RE: **Drive Thru Restaurant**  
**700 Coors Blvd NW**  
**Grading Plan Stamp Date: 5/15/20**  
**Hydrology File: J11D039**

CESO, Inc. is pleased to submit this letter to you in response to your previous review letter dated 09/23/2019.

Drawing No. **GD1.0**

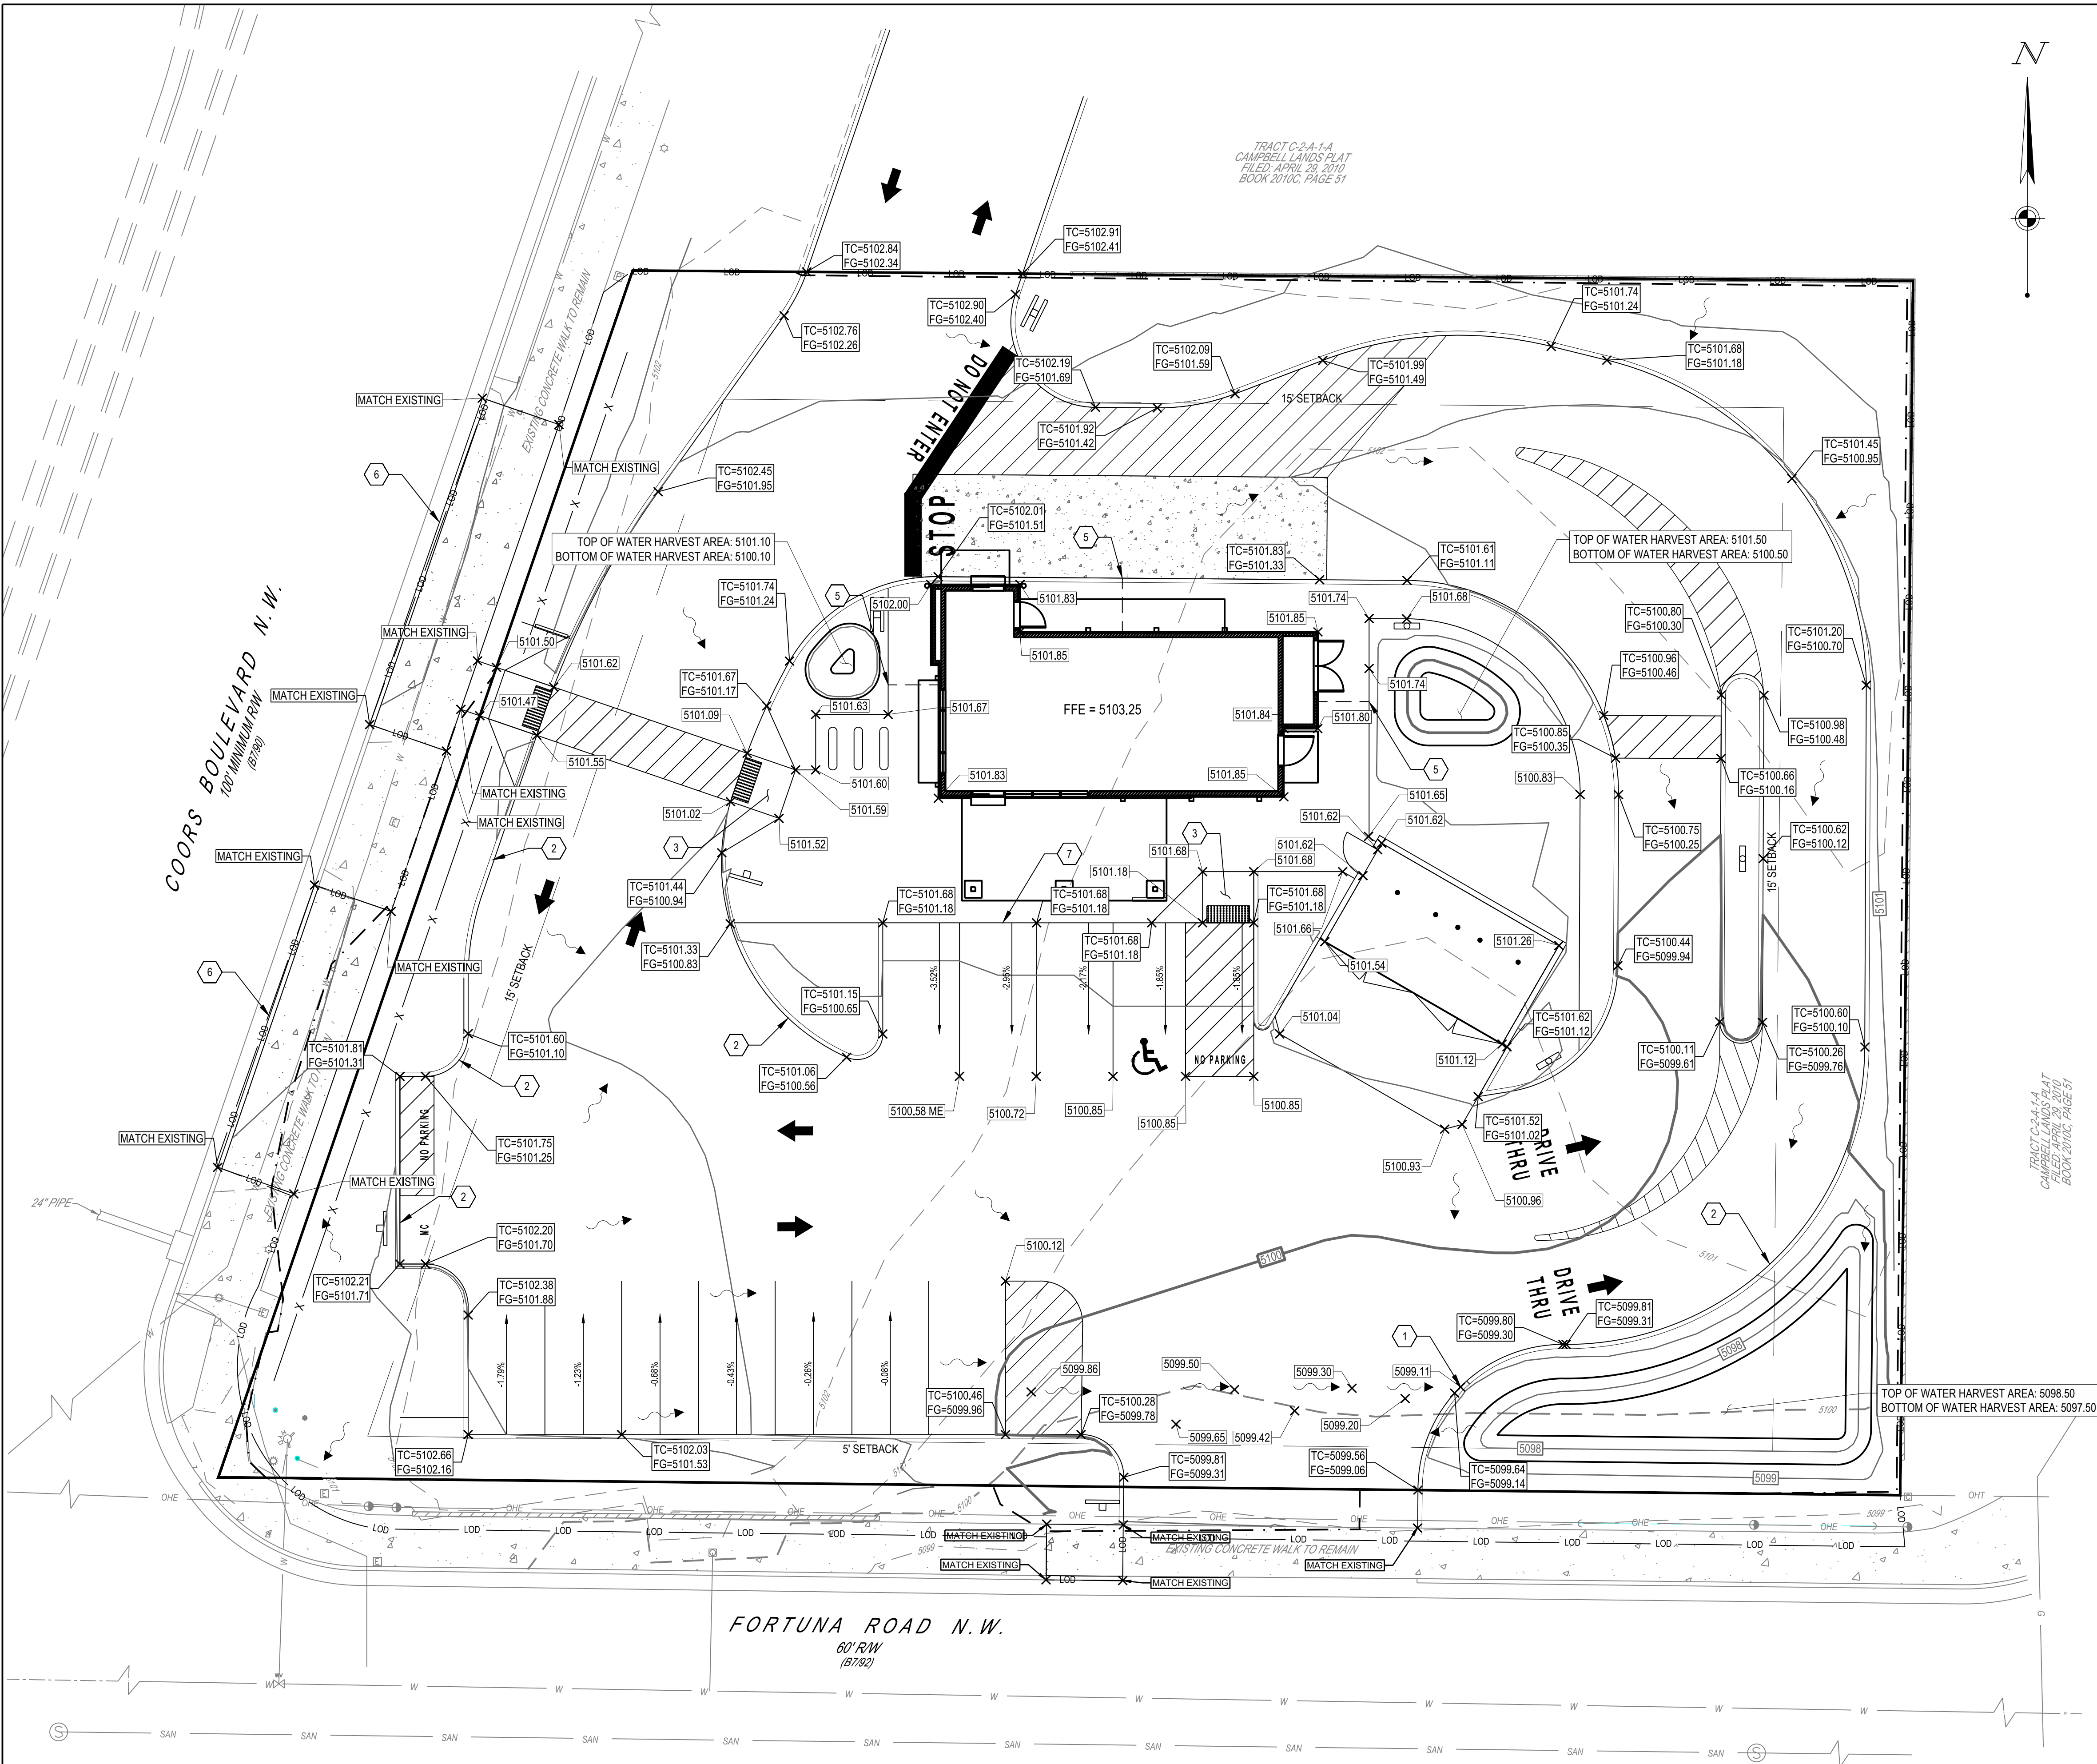
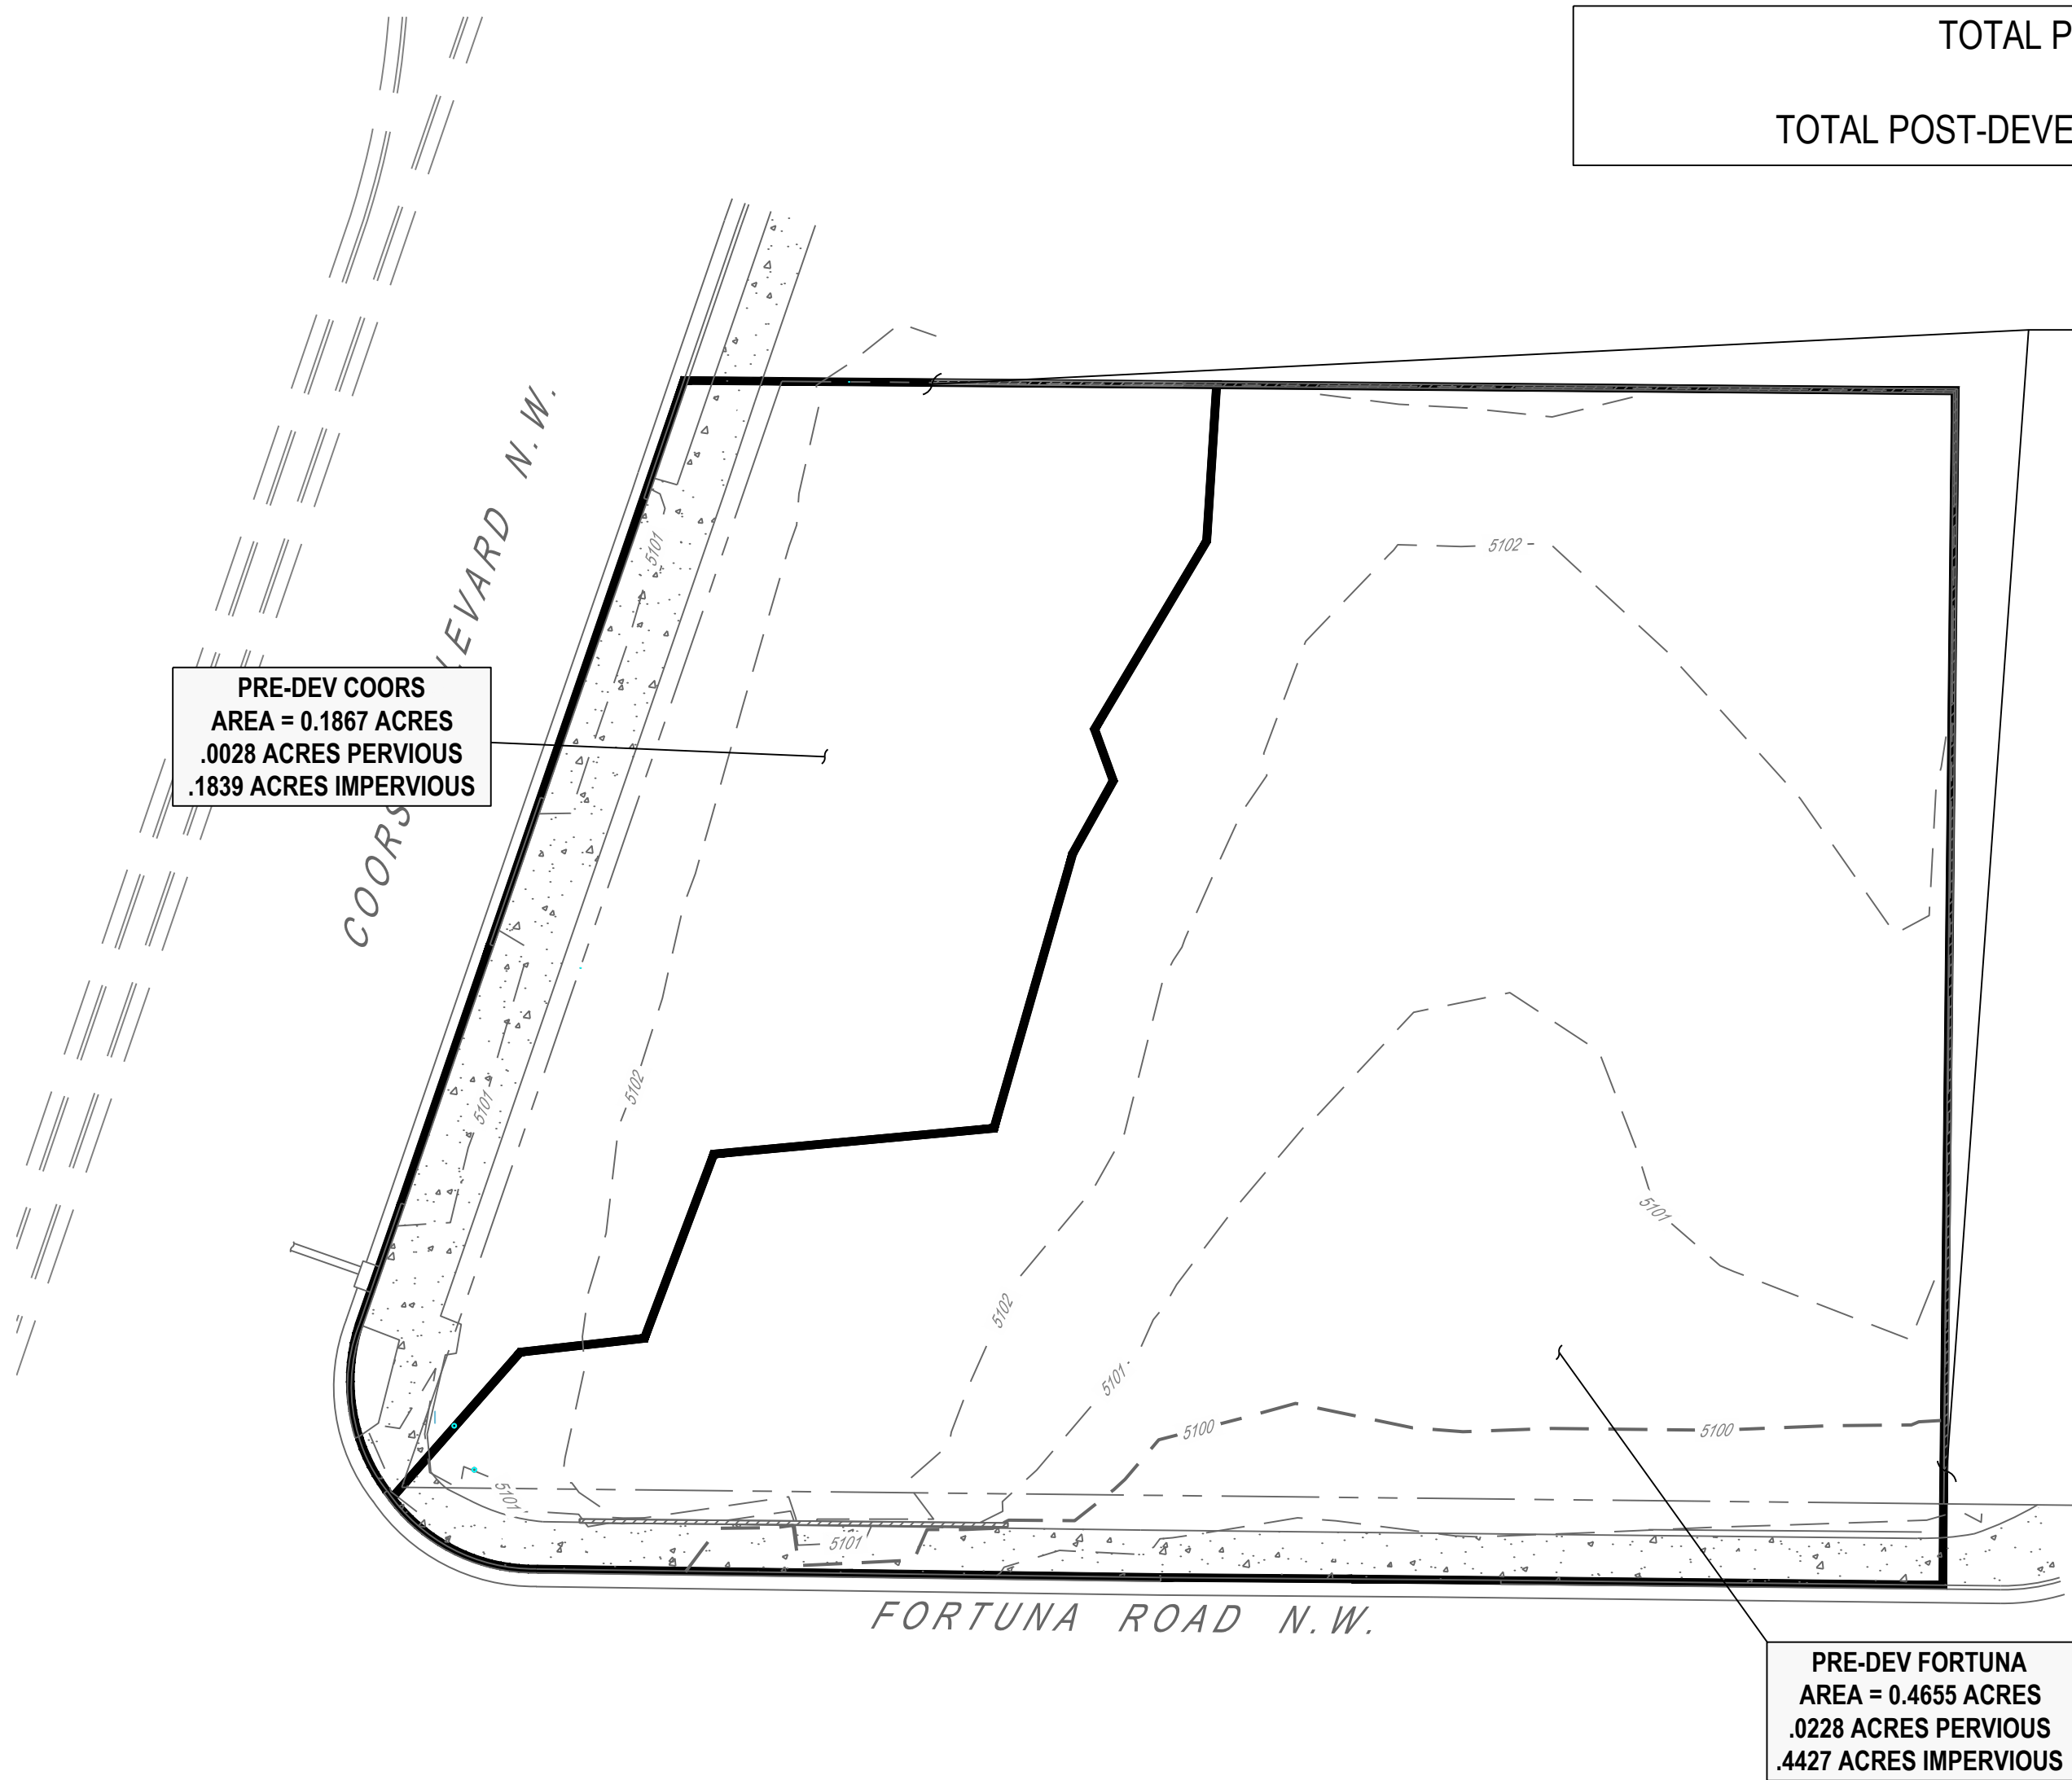
1. Runoff from impervious areas needs to be routed into the stormwater quality (SWQ) ponds. Please provide the SWQ volume calculations for each basin draining to each pond. The stormwater quality ponds need to be sized for the areas draining to them. It appears a large portion of the parking lot and roof simply flows out the driveway onto Fortuna.

7. Show the work to close the extra driveway cut, reconstruct the remaining two driveways per ADA requirements, and any other work required in the ROW. Include spot elevations at flowline and highpoint, demonstrating a 0.87' (min.) waterblock.

8. Add a note on the Grading Plan, "Prior to any work within the New Mexico Department of Transportation (NMDOT) Right-of-Way, an NMDOT permit will be required." Provide a copy of the issued permit prior to requesting Certificate of Occupancy.

**Response: Stormwater Quality ponds have been added to the site to comply with City regulations. See Sheet GD1.0 and GD1.1 for reference.**

**Response: Spot elevations and notes to close extra driveway cuts have been added to sheet GD1.0 per comment.**

**Response: Note added to Sheet GD1.0 per comment.**
